Review of “Observations of wind farm wake recovery at an operating wind farm” by Krishnamurthy, R., Newsom, R., Kaul, C., Letizia, S., Pekour, M., Hamilton, N., Chand, D., Flynn, D. M., Bodini, N., and Moriarty, P.

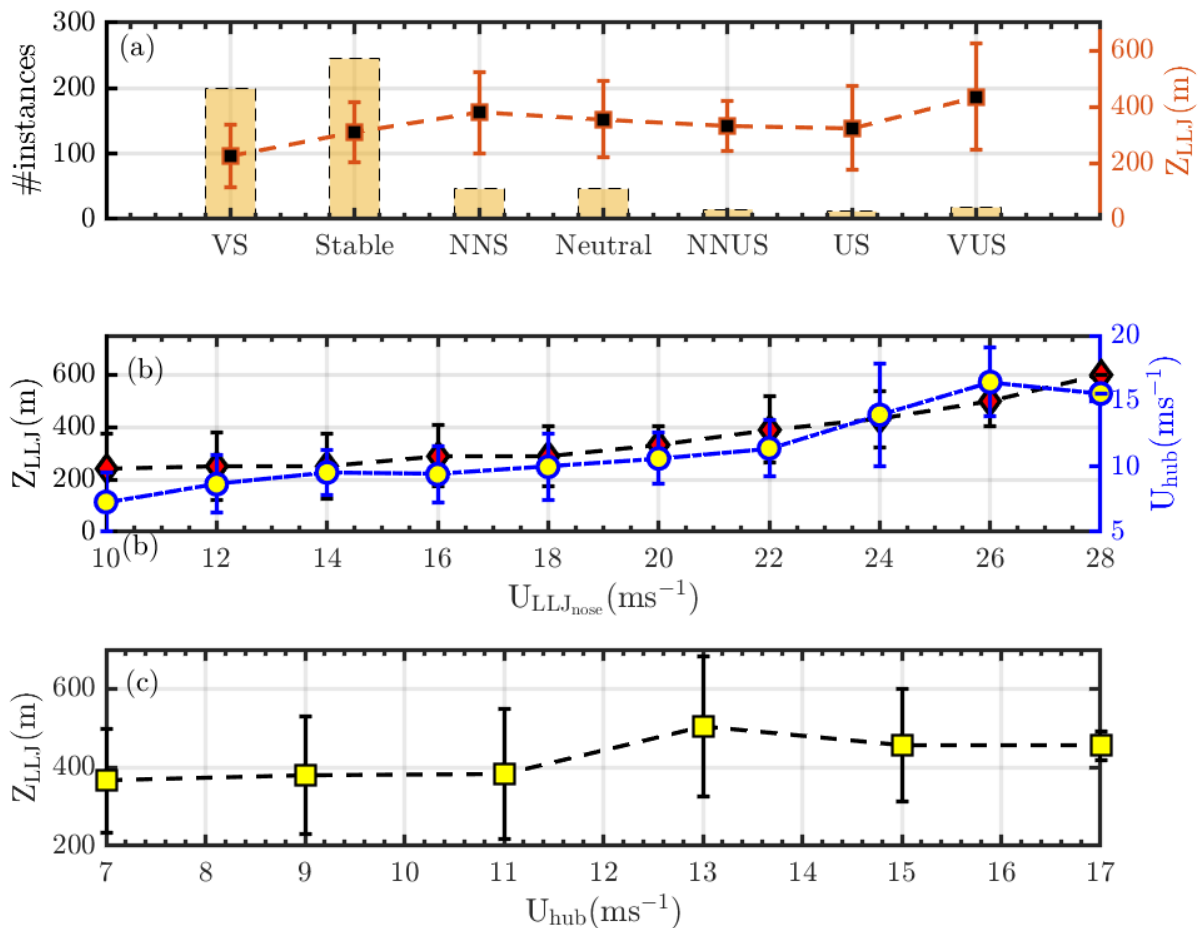
36. L.368: This result is very interesting and should be shown in a Figure somewhere. From Figure 6, this statement cannot really be verified

We have rephrased this sentence, and it currently reads: "Figure 4b shows LLJ nose wind speed as a function of median  $Z_{LLJ}$  per wind speed bin and hub-height wind speed and Figure 4c shows  $Z_{LLJ}$  as a function of hub-height wind speed. It is evident that higher the  $Z_{LLJ}$ , higher the jet nose wind speed and higher the hub-height wind speed."

Please see below the updated figure in the text and associated caption.

Figure 7. Probability distribution of LLJ heights (ZLLJ) upwind (site A2) and downwind (site H) of the King Plains wind farm during southerly wind directions.”

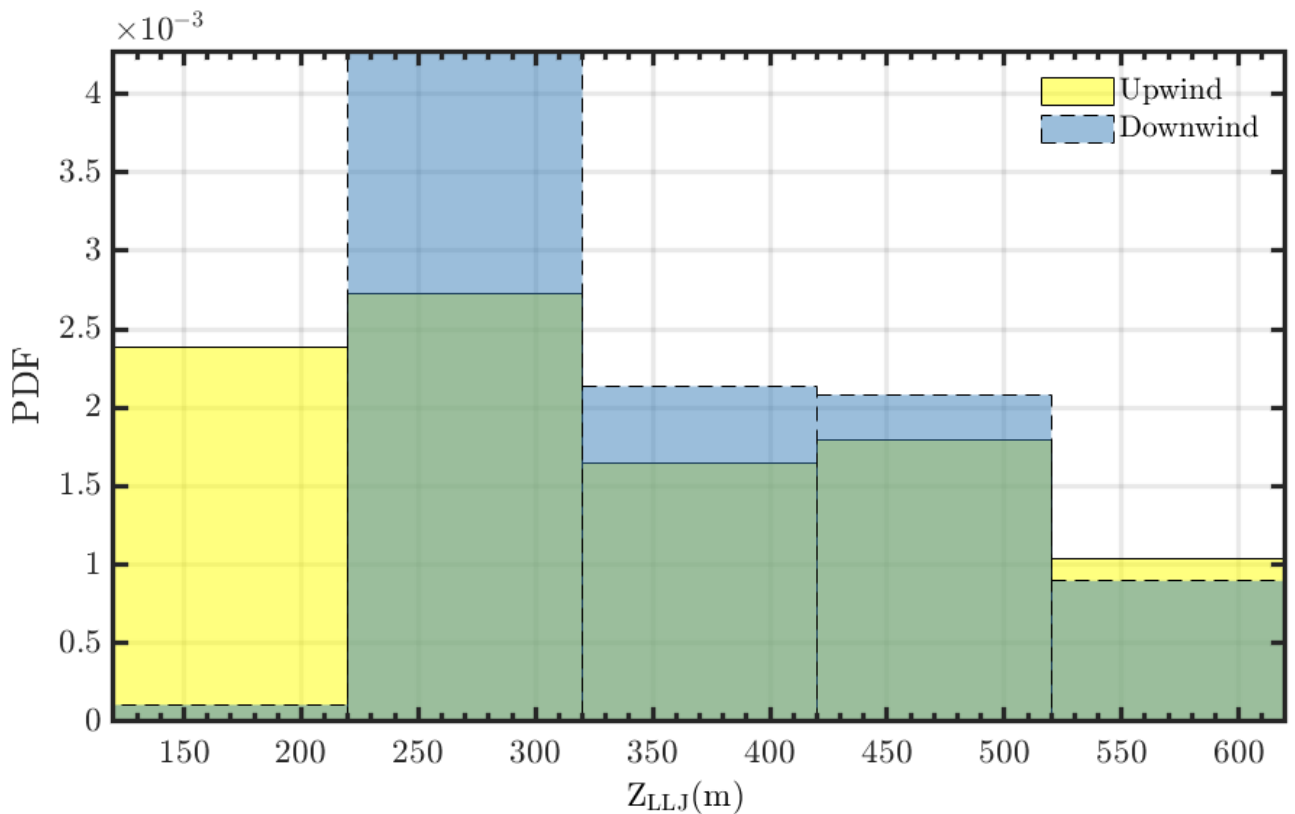
39. L. 400: I think it is more common to use up- and downstream instead of up- and downwind. Also, the authors state, that the LLJ height is modulated when passing through the farm. Here it would be really interesting to see how many LLJ events are recorded in the different core height intervals and maybe also provide another plot showing the LLJ height up- vs downstream of the wind farm.

Thanks for the comment, we initially had a similar plot but removed it due to concerns on length of the manuscript. We have added the below figure and associated text.

“Figure 7 illustrates the probability distribution of LLJ events at the upwind site (A2) and downwind site (H) of King Plains wind farm. The data reveal that the difference in LLJ height between the upwind and downwind sites is greater below approximately 250 to 300 m but diminishes at higher LLJ heights. Notably, there is a reduced frequency of LLJs observed downwind of the wind farm when LLJs occur below the rotor layer. Future research will focus on further analyzing the effects of LLJs that occur beneath the turbine rotor layer.
